**AGENDA**  
**CITY OF MARSHALL PLANNING COMMISSION**  
City Hall-Council Chambers-323 W. Michigan Ave., Marshall, MI  
Wednesday – April 8, 2015 – 7:00 p.m.

**Report To:** Chairman Davis and Planning Commission Members  
**From:** Natalie Dean, Director of Community Services  
**Subject:** City Hall Parking Lot, 323 W. Michigan Ave.  
**Meeting Date:** April 8, 2015

**Report To:** Chairman Davis and Planning Commission Members  
**From:** Natalie Dean, Director of Community Services  
**Subject:** Taco Bell, 15955 W. Michigan Avenue  
**Meeting Date:** April 8, 2015

SCALE: AS SHOWN
PROJ. #: 120108
DATE: 3/27/2015
SHEET
C-102
SITE PLAN REVIEW

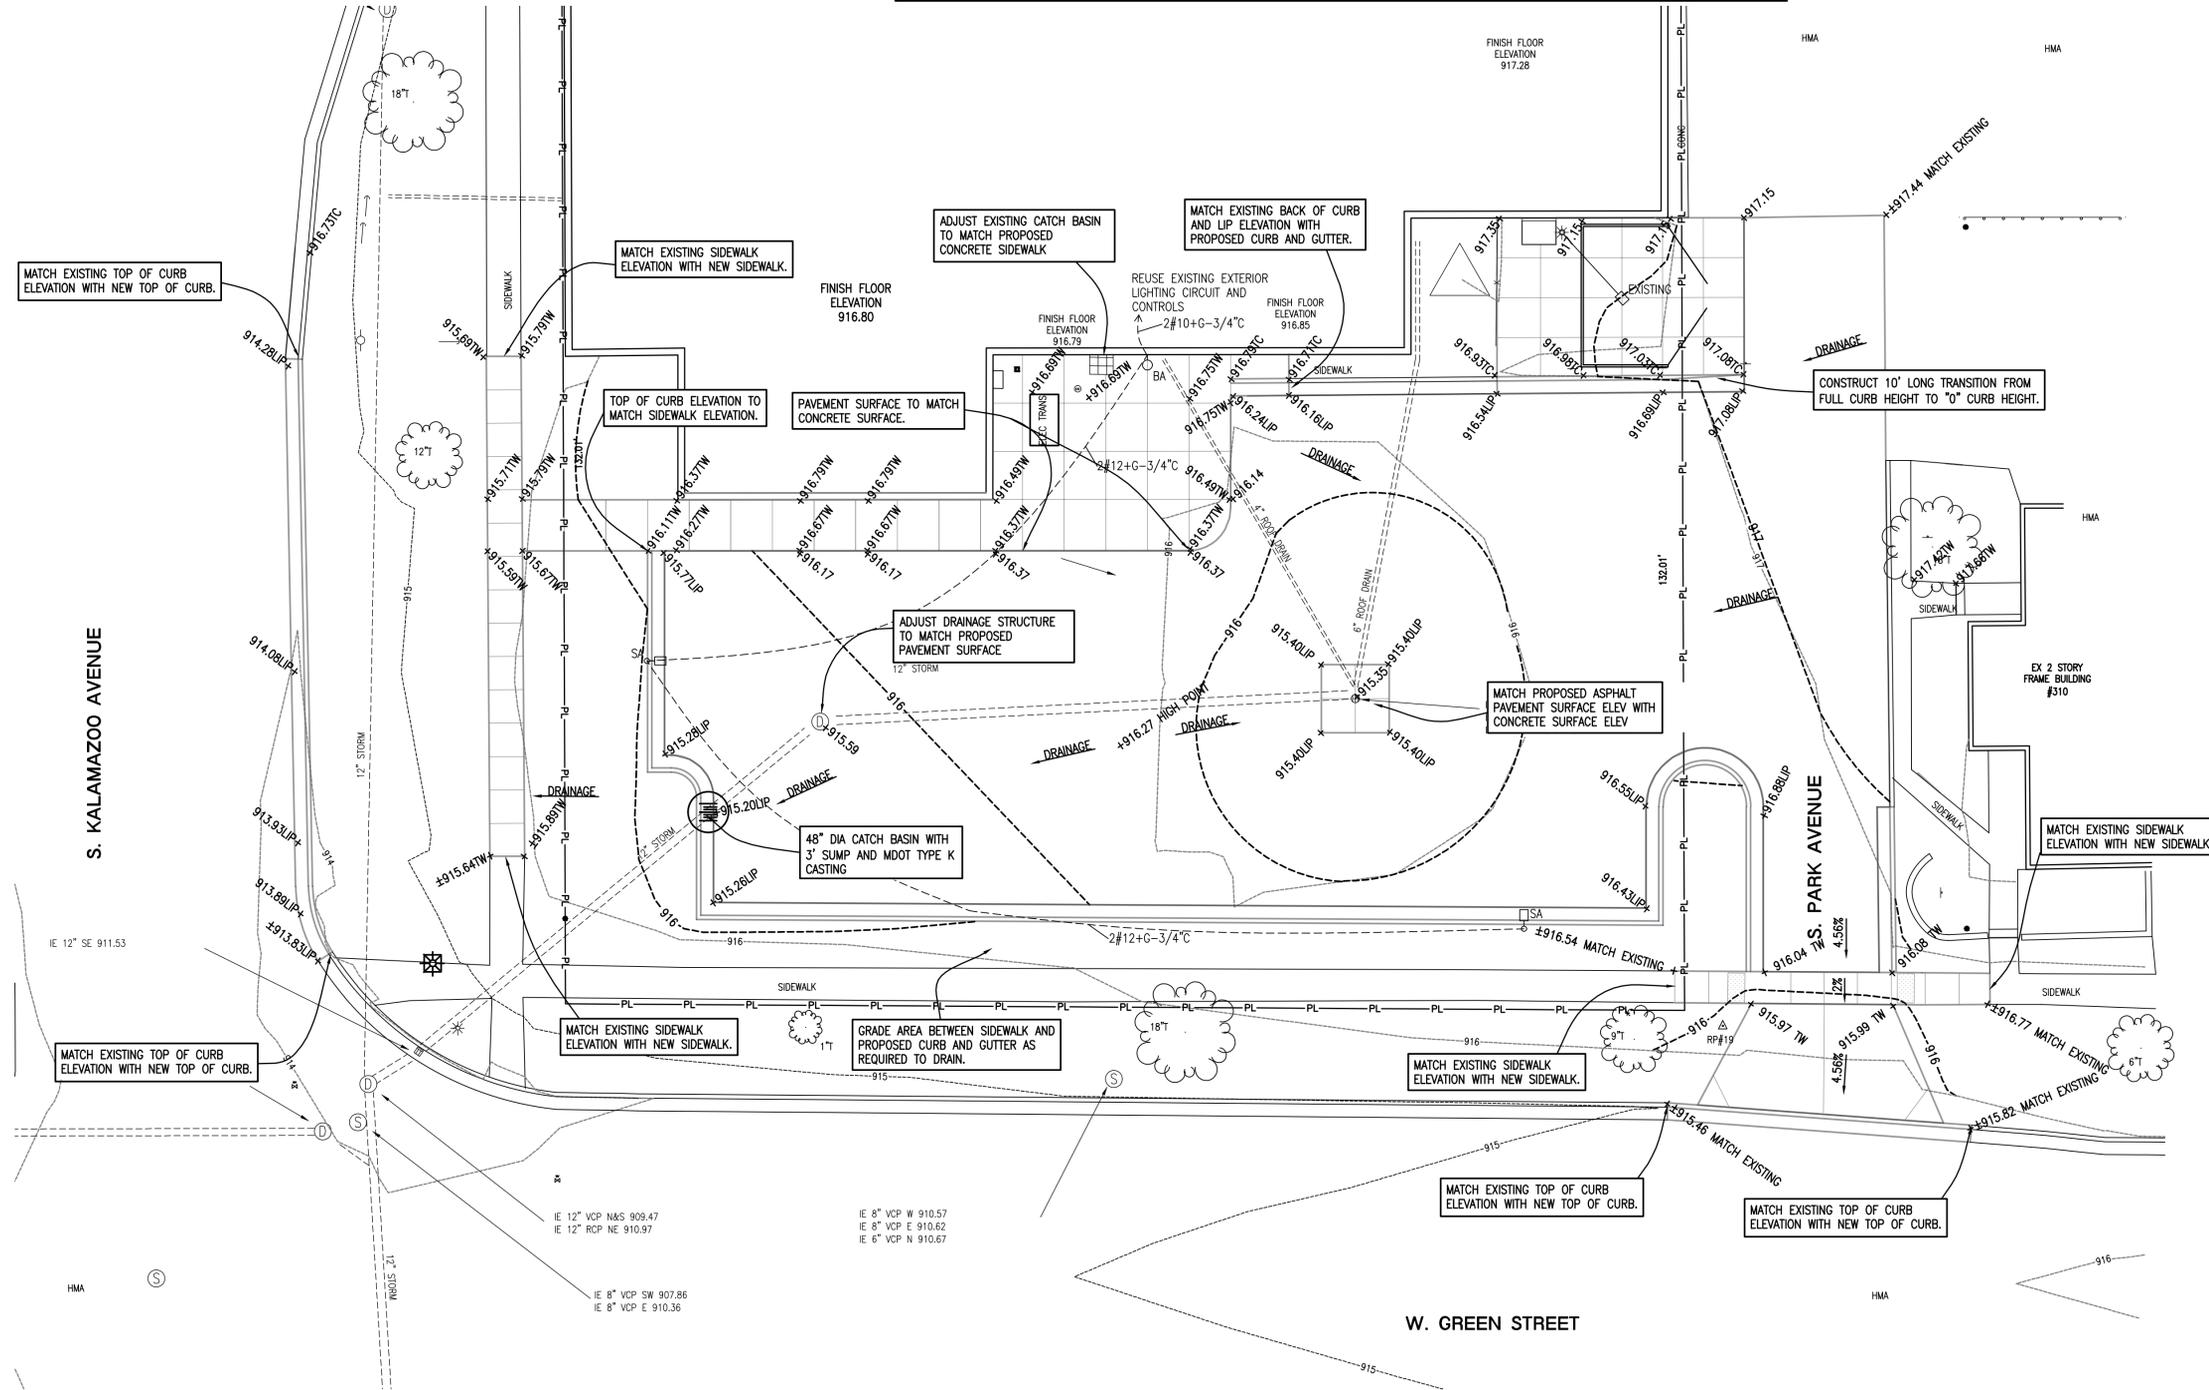
- Increase parking spaces to 10' wide. (Tom's request)
- Re-grade slope of driveway. (Tom's request)
- Indicate location of light poles on the site and clarify that the height will be no more than 20'.
